# Access Compliance Report

## Public Rights-of-Way

Intersection ID: 4017	Main Street: GALLOWAY_RD	Cross Street: KENDAN_KNOLL_DR	Location: SW
ADA ID: 9FEC3B99228F	Ramp Type: Perp	Initial Pass/Fail: Fail	Overall Compliance: No
Severity Score: 12.5			
Codes/Mitigation Info/Possible Solution		Field Measurements/Component Compliance

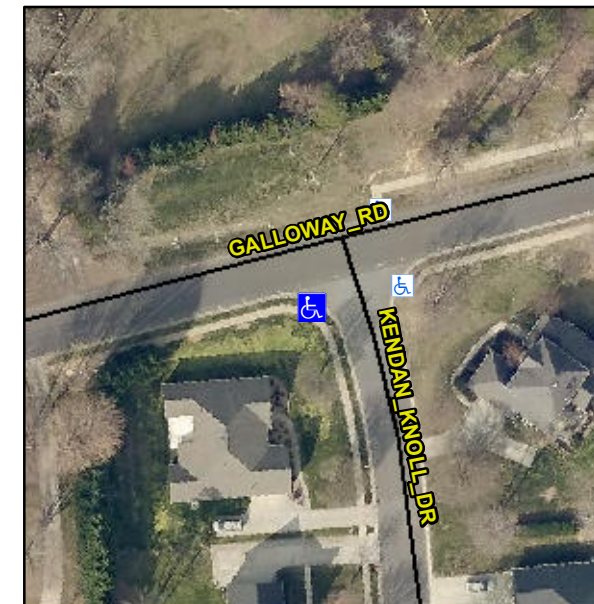
**Not Found, R304.2.2**

Compliance	Description	Data	Compliance	Description	Data
N/A	Ramp Length (in)	50.0	No	Ramp Slope (%)	9.6
Yes	Ramp Width (in)	48.0	Yes	Ramp XSlope (%)	1.8
N/A	Flare Type LT	N/A	N/A	Flare Type RT	N/A
N/A	Flare Slope LT (%)	N/A	N/A	Flare Slope RT (%)	N/A
N/A	Flare Traversable LT?	N/A	N/A	Flare Traversable RT?	N/A
N/A	Landing Length (in)	N/A	N/A	DWS Provided?	N/A
N/A	Landing Width (in)	N/A	N/A	DWS Contrast?	N/A
N/A	Landing Slope (%)	N/A	N/A	DWS Length (in)	N/A
N/A	Landing X Slope (%)	N/A	N/A	DWS Full Width?	N/A
N/A	Landing Curb? (Y/N)	N/A	N/A	DWS Offset (in)	N/A
N/A	Shared Landing?	N/A			
N/A	Gutter Ponding?	N/A	N/A	Gutter Slope (%)	N/A
N/A	Gutter Lip Ht (in)	N/A	N/A	Gutter X Slope (%)	N/A
N/A	Painted X Walk1?	No	N/A	Painted X Walk2?	N/A
	X Walk 1 Direction	To E		X Walk 2 Direction	N/A
N/A	X Walk 1 Width (in)	N/A	N/A	X Walk 2 Width (in)	N/A
	X Walk 1 Slope (%)	3.1		X Walk 2 Slope (%)	N/A
	X Walk 1 X Slope (%)	5.4		X Walk 2 X Slope (%)	N/A

**Remove & Replace Entire Ramp.**
